WOODCREEK SUBDIVISION,

The purpose of this application is to create a 371 lot subdivision from five parcels.

APPLICATION NUMBER 19 DATE July 5, 2007

DETAIL SITE PLAN

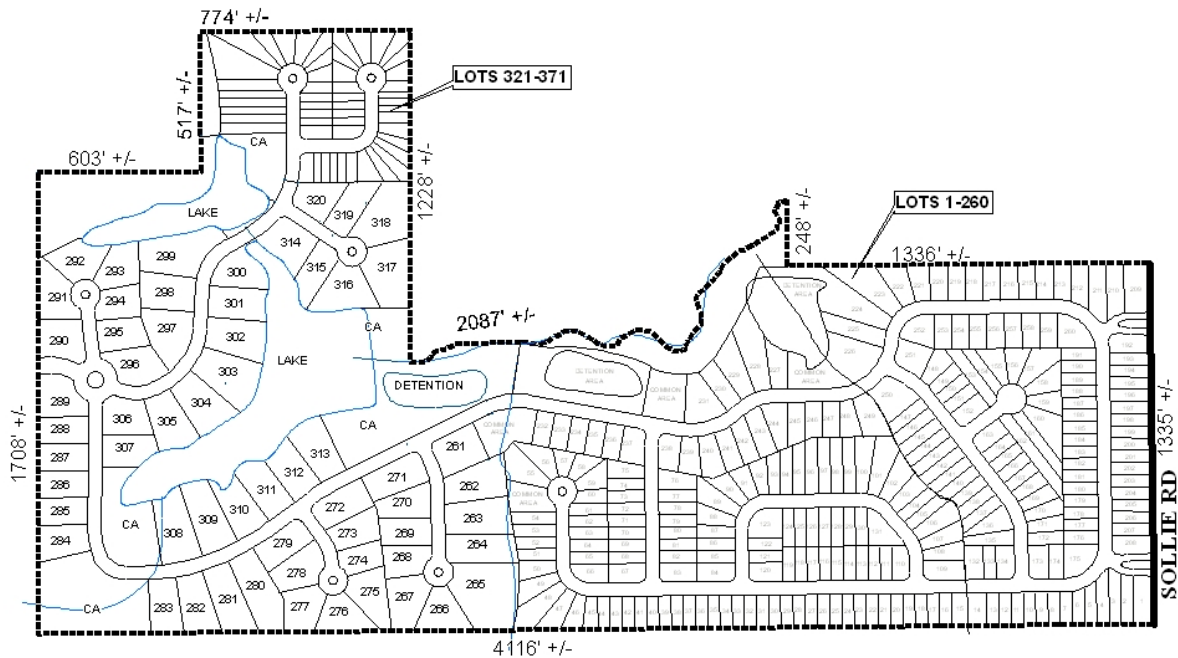
The site fronts onto Sollie Road, a proposed major street, Lesley Court, a street-stub of minor street, Shasta drive, a street-stub of a minor street, and unpaved street-stubs that connect to Tara Drive North, West and South. The right-of-way for Sollie Road should be a minimum of 100-feet, however, it appears that it ranges from 80 to 90 feet in this location. Dedication of right-of-way sufficient to provide a minimum of 50-feet, as measured from the centerline, should be provided along the entire portion of the site where it abuts Sollie Road.

Access management is a concern for the development due to the frontage on a proposed major street, the lot widths, and the total number of lots. Direct access to Sollie Road for any lots with frontage on Sollie Road should be denied. All other lots should be limited to one curb-cut each, with the size, design and location of all curb-cuts to be approved by the Mobile County Engineering Department.

Access management is a concern as it relates to public safety. The 371-lot subdivision, as proposed, will have only three connections to existing public streets. No additional street-stubs are proposed, even though street-stubs exist off of Tara Drive North, West and South, as well as Shasta Drive to the South. Also, three parcels to the South of the site are large enough to warrant street-stub connections, however, none are proposed. It is recommended that one street-stub be provided in the vicinity of proposed Lots 331 and 332, or Lot 318, and that a street-stub be

provided to Shasta Drive, near Lot 281 and 282. It should be noted that the plat does not correctly depict the existing lots in Ashley Estates, 2nd Addition, Part B, as it omits the existing street-stub. Two street-stubs should also be provided to two of the three large parcels South of the site; specifically it is recommended that street-stubs be provided to parcels R023304194000002. and R023304194000001. so that adequate connectivity is ensured for the proposed 371-lot subdivision and adjacent future development.

Common areas are proposed throughout the development, including the round-about, road medians, detention areas and other areas. There also appear to be areas of land that are not lots and are not labeled as common areas: these areas should be specifically identified. All common areas should be quantified in square feet, with differentiation of areas set aside for detention. A note should also be placed on the final plat, if approved, stating that maintenance of the detention and common areas is the responsibility of the subdivision's property owners.

It appears that some lots are missing lot lines that separate them from common areas, and that some common areas have extra lines that effectively cut them off from adjacent common areas. The plat should be revised to correct the lot and common area delineation.

Finally, the 25-foot minimum building setback line, required in Section V.D.9., is not shown for the subdivision, but would be required on the final plat, if approved. The setback line should reflect any required dedication, and should be shown from all road frontages, including for those lots with double frontage.

- 1) revision of the plat to show dedication of right-of-way sufficient to provide 50-feet, as measured from the centerline of Sollie Road;
- 2) revision of the plat to provide one street-stub connection in the vicinity of Lots 331 - 332, or Lot 318;

- 3) revision of the plat to provide a street-stub connection to Shasta Drive, near Lot 281 – 282;
- 4) revision of the plat to provide one street-stub connection each to parcels R023304194000002. and R023304194000001.;

- 5) labeling of each lot with its size in square feet, or provision of a table with the same information;
- 6) revision of the plat to label all common areas, detention areas and any unidentified areas, and provision of a table quantifying common area in square feet (by phases);

- 15) revision of the plat to correct any missing or extra lot lines.
